## SERVICE LETTER 209

### Fire Boss AT-802 (Two Seater) Removal of Fixed Ballast

<b>Aircraft Makes/Model(s):</b>	<b>Float Model(s):</b>	<b>Compliance:</b> Optional	<b>By:</b> MAB
Air Tractor AT-802 Only (Two Seater)	10000A	<b>Part Number:</b> 1011926	<b>Approved:</b> SDW
		<b>Date:</b> 7/1/2021	<b>Revision:</b> A

Figure 1

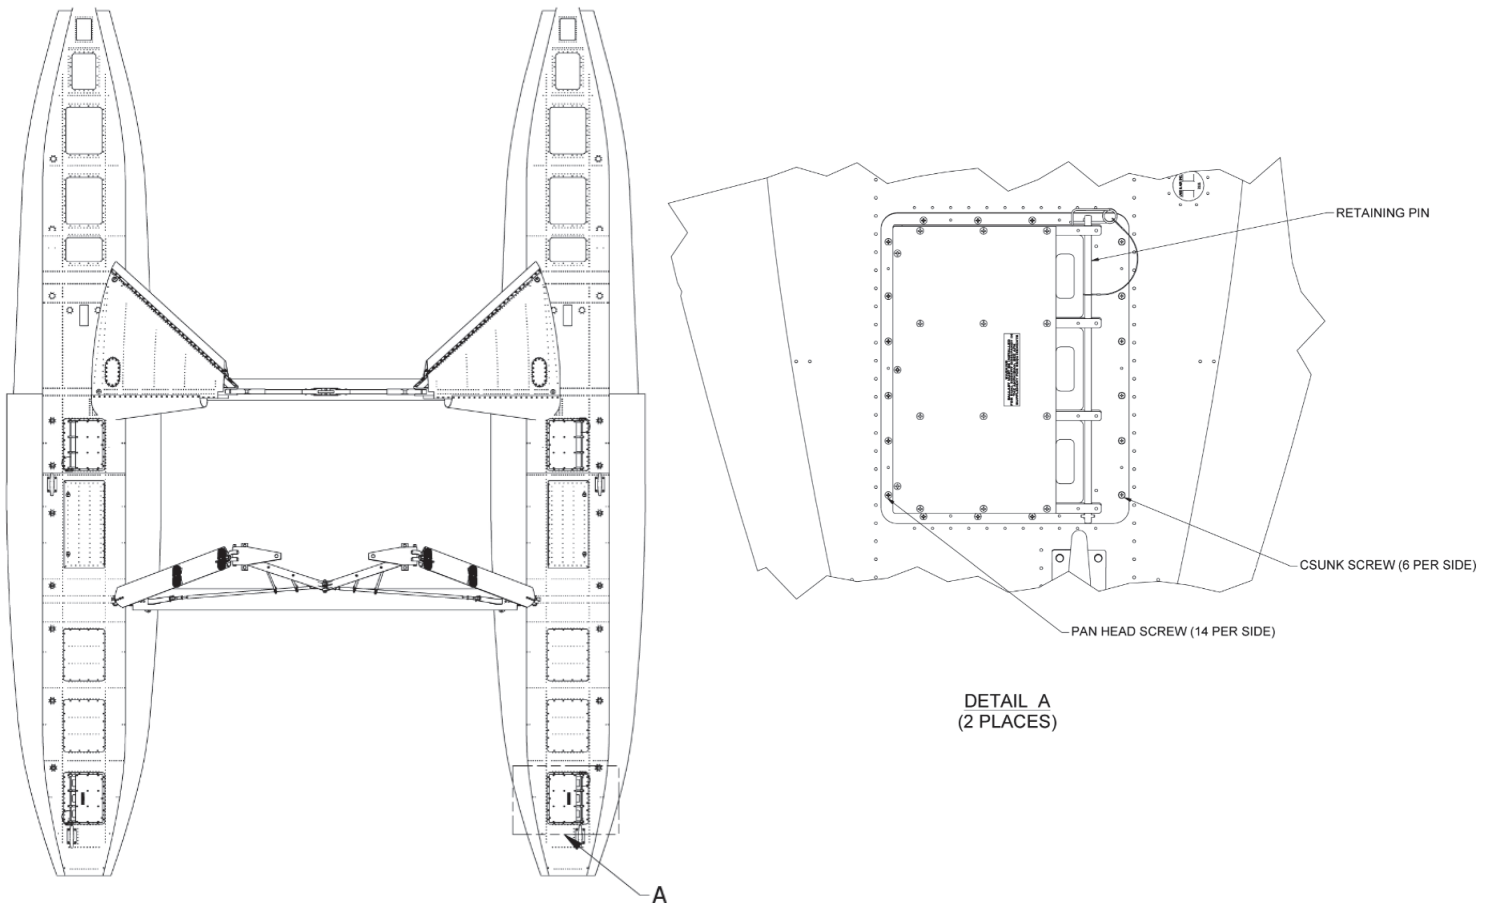
1. Temporarily remove forward ballast assemblies from floats by removing (14) pan head screws and (6) countersunk screws per float. Remove retaining pin as needed to access screw heads. Reference Figure 1.
2. Remove the fixed ballast plates from bottom of assembly by removing (16) AN3 bolts. Reference Figure 2.
3. Either:
  - a. Re-fasten the thicker (1") ballast plates using (8) AN3-12A and (8) AN3-15A bolts. Reference Figure 2. The longer bolts are used closest to the center, screwing into the two ribs which form the bay for the center removable ballast plate.
  - b. Remove both the 1" and ½" ballast plates from aircraft. New hardware not required.
4. Reinstall both forward ballast assemblies using (14) pan head screws and (6) countersunk screws per float. Reinstall retaining pin, if removed.
